CNG Gen 3 RM Refuse Fuel System PRD Retrofits

Agility Fuel Solutions LLC, a subsidiary of Hexagon Agility Inc. (Hexagon Agility®), has determined that certain OMB pressure relief devices (PRDs) have been observed to crack or fracture. The PRD failure mode—seen to occur at or near first fill—can result in a sudden release of the high-pressure gas contained in the CNG fuel system to the atmosphere.

Hexagon Agility® has created a PRD retrofit kit, p/n 20535030, to correct this issue on Hexagon Agility® Gen 3 roof mount (RM) refuse fuel systems.

FIGURE 8: Right cylinder valve plumbing after installation of left PRD vent tube assembly and live PRD tube

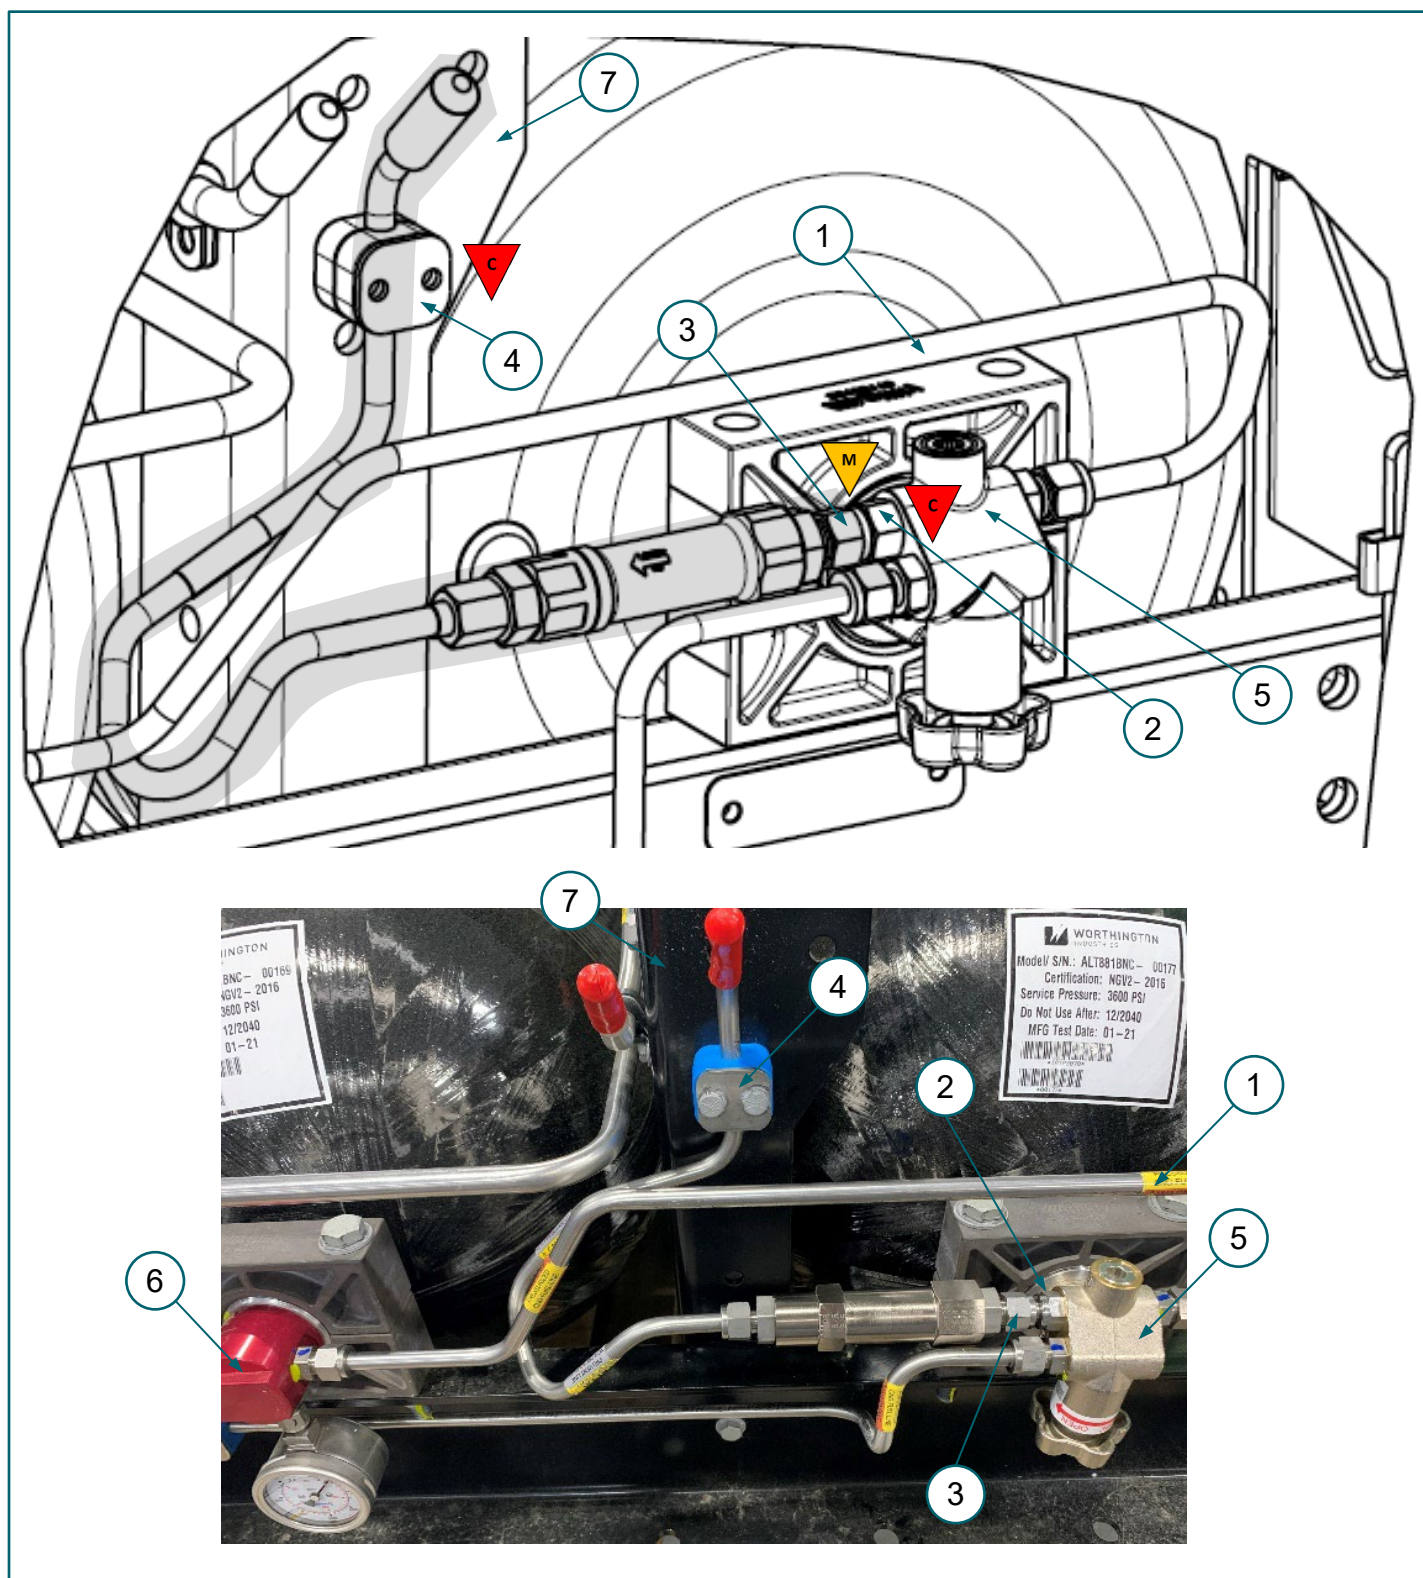
19. Install (1) live PRD tube, p/n 20437408, from retrofit kit on (5) right cylinder valve and (6) right manifold. **FIGURE 7** and **FIGURE 8**

20. Use a 7/16-in socket and 7/16-in wrench to secure (*shaded*) right PRD vent tube assembly to (7) structure using (4) tube clamp and fasteners. **FIGURE 8**

Tighten tube clamp fasteners to 8 ft-lbs (10.85 Nm) and mark bolts with Torque Seal.

FIGURE 10. RM fuel system cover components

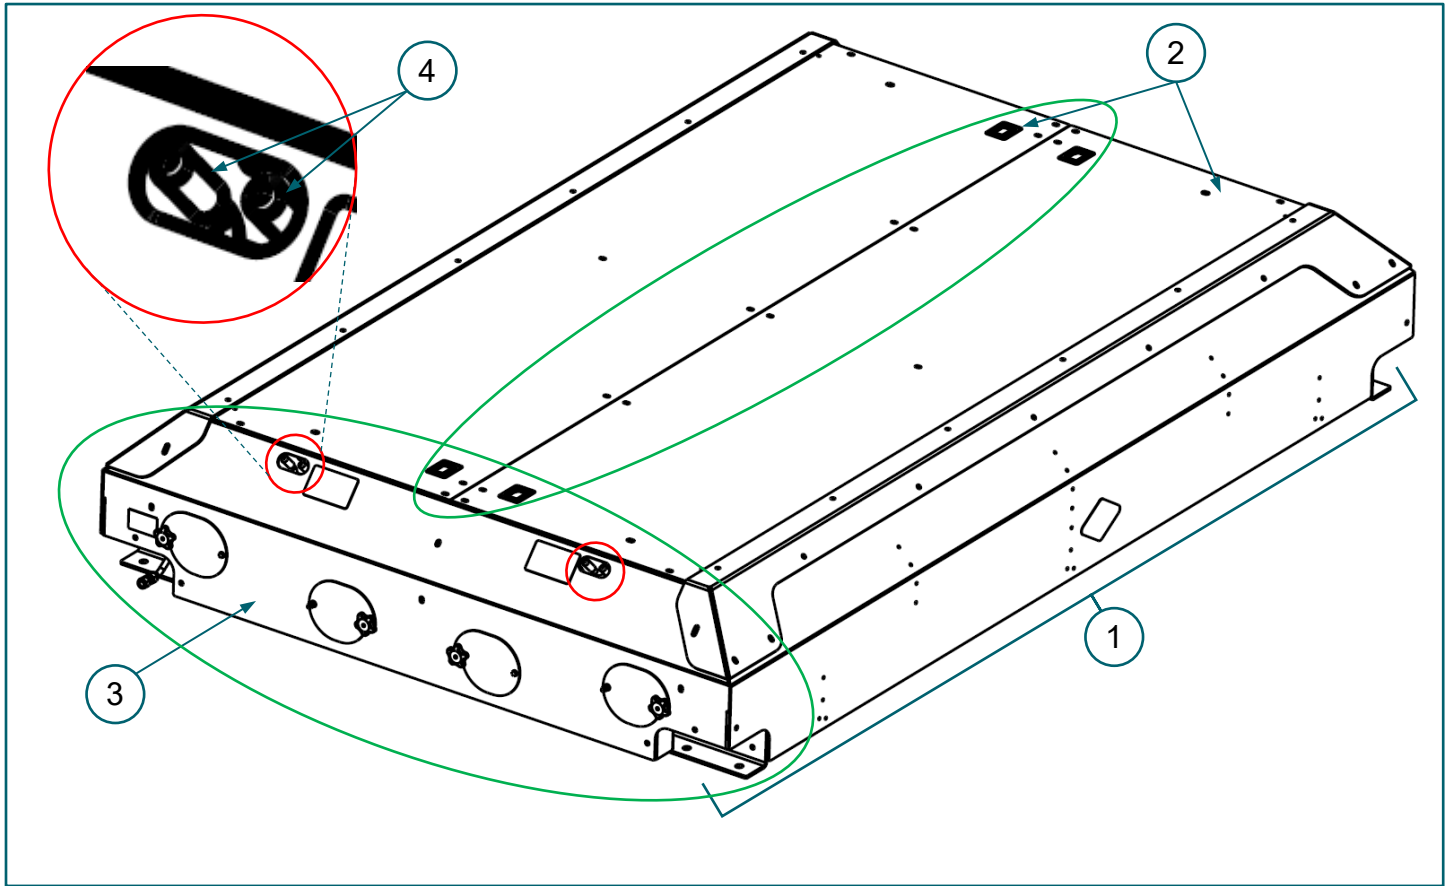
Verify: 1) PRD vent tube caps do not touch valve end cover vent openings, and 2) vent cap tips are flush with the underside of the cover OR do not protrude more than 0.5-in (12.7 mm) above the cover. FIGURE 10
